SERVICE BULLETIN

CHECKING OR REPLACEMENT

OF FLEXIBLE FUEL LINE

SB-912-054 UL

Fig. 1

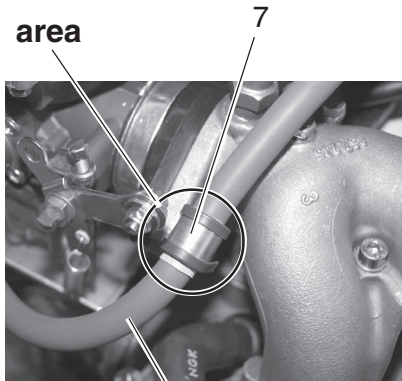
Visual inspection of the fuel line (1) in the area clamp (7) and both ends of the yellow protection cover. (see Fig. 1)

◆ **NOTE:** A possible crack can be observed by careful bending of the fuel line. If you notice cracks or porosity then you need to replace the fuel line in accordance section 3.1.2.

2. Install both cable clamp (7) in accordance with Fig.1 on the fuel line.

Fig. 2
08184

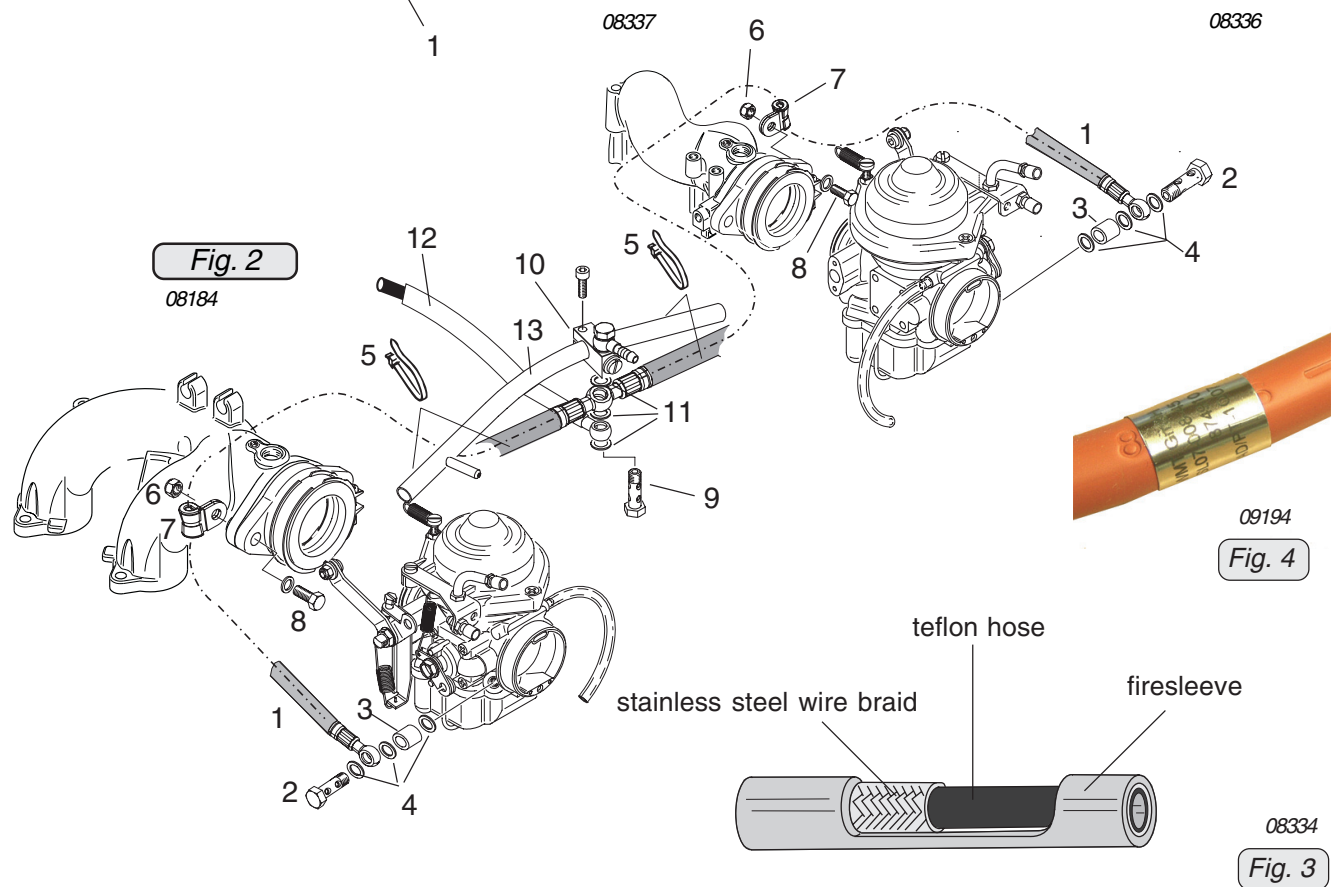
1. Unscrew the banjo bolt (2) with distance sleeve (3) and 3 gasket rings (4).

2. Cut the cable tie (5).

3. Remove hex. nuts M8 (6) together with clamp (7). Held in place by hex. screw (8).

4. Remove banjo bolt (9) from clamp block (10) together with 3 gasket rings (11).

◆ **NOTE:** The gasket rings 8x13 (4), used on the banjo bolt of the carburetor, are of different thickness compared to the gasket rings (11), used on the banjo bolt of the clamp block.

5. Remove the fuel line (12).

1. Install flexible fuel line (1 and 12) and the banjo bolt (9) with new sealing ring (11) on the clamp block (10). Tightening torque of banjo bolt (9) 10 Nm (90 in.lb). Check that the fuel lines are not under strain or tension.

3. Install the fuel line (1) with distance sleeve (3) and sealing ring (4) on the carburetors. Tightening torque of banjo bolt (2) 10 Nm (90 in.lb). Place cable clamp (7) into position.

4. For proper support. Install the clamp (7) and hex. nut M8 (6) with LOCTITE 221. Tightening torque of hex. nut (6) 15 Nm (133 in.lb).

5. Fix the fuel line at the compensation tube with 2 cable ties (5).

08334
Fig. 3

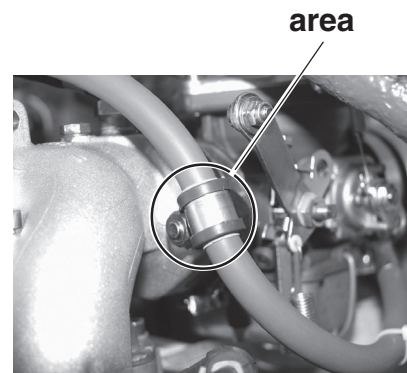
Due to a chemical reaction of the adhesive (in the area of the yellow position marks on the firesleeve) porosity and/or cracks on the firesleeve can occur.

Fuel leakage within this area is not an issue, as only the fireproof protection hose is affected and the fuel is routed in a wire braid reinforced teflon hose.
